SUB07-00057

Subdivision Name:	Mesquite Hills Unit Two	
Type Request:	Revised Major Combination	
Property Owner:	Newman Ranch Partners, L.P. and El Paso Water Utilities, PSB	
Developer:	Newman Ranch Partners, L.P.	
Engineer:	Conde, Inc.	
Surveyor:	Conde, Inc.	
Location:	Northwest of Dyer Street and Southeast of U.S. Highway 54	
Acres:	73.854	Representative District: 4
Planning Area:	Northeast	Present Zone: R-5/c and R-F
Park Credits Applied:	3.76 Acres	Park Zone: NE-7

STAFF RECOMMENDATION:

ATTACHMENT 6

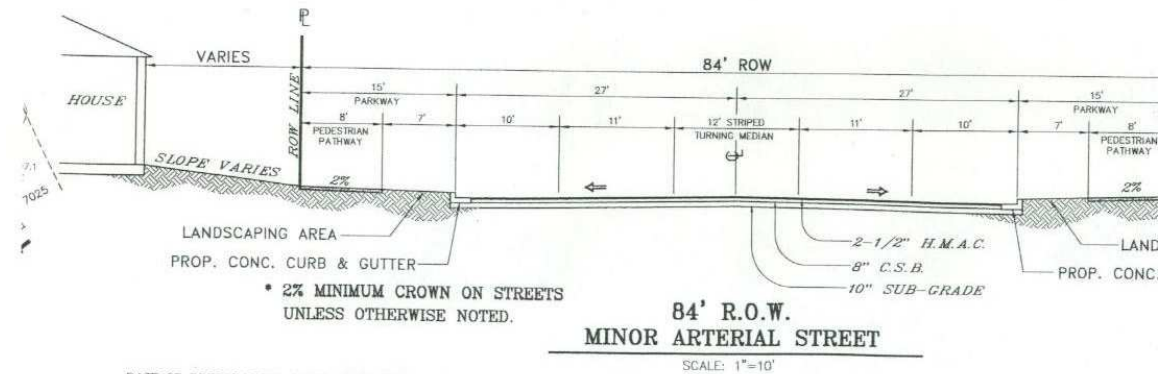
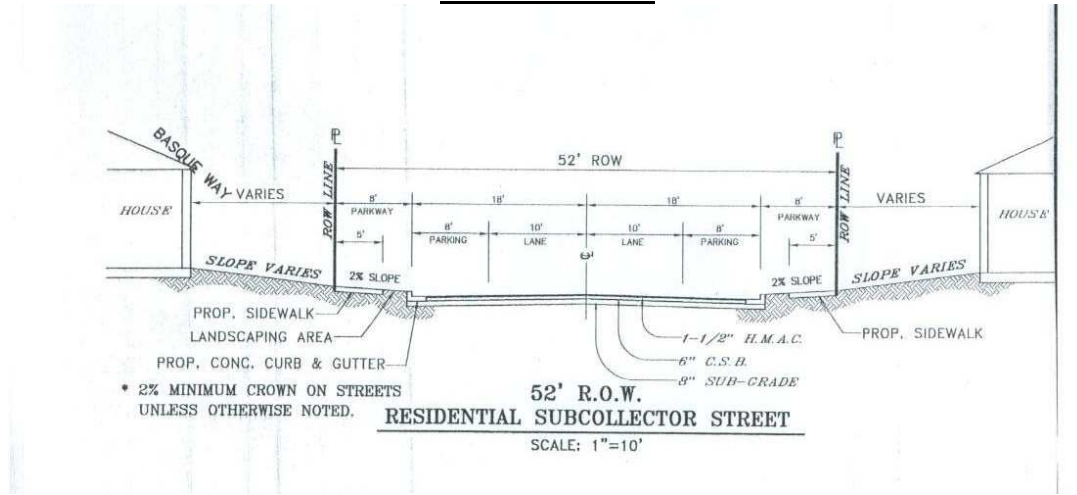
1. To allow for a jogging path within the parkway of Mesquite Hills Drive (84' R.O.W.).

- Subdivision Improvement Design Standards Section 3-2 revised cross section to allow for a 5' sidewalk instead of a 4' sidewalk (for all Residential Sub-collector streets) in order to provide improved Pedestrian safety and mobility.
- Subdivision Improvement Design Standards Section 3-50 to allow for a 70' Radius Heel on (Jericho Tree Dr., Mesquite Lake Ln., Falling Leaf Cir., Autumn Wheat Dr., Jim Webb Dr., Sachet Cliff Dr.) for proper traffic circulation while improving traffic safety.
- Subdivision Improvement Design Standards Section 19.08-06 to allow for a location map scale of 1" = 1,000' instead of 1"=600' to provide a more legible location map.
- Subdivision Improvement Design Standards Section 3-8 to allow for a jogging path within the Parkway of a Minor Arterial in Mesquite Hill Dr. (84' ROW) in order to provide improved Pedestrian safety and mobility.
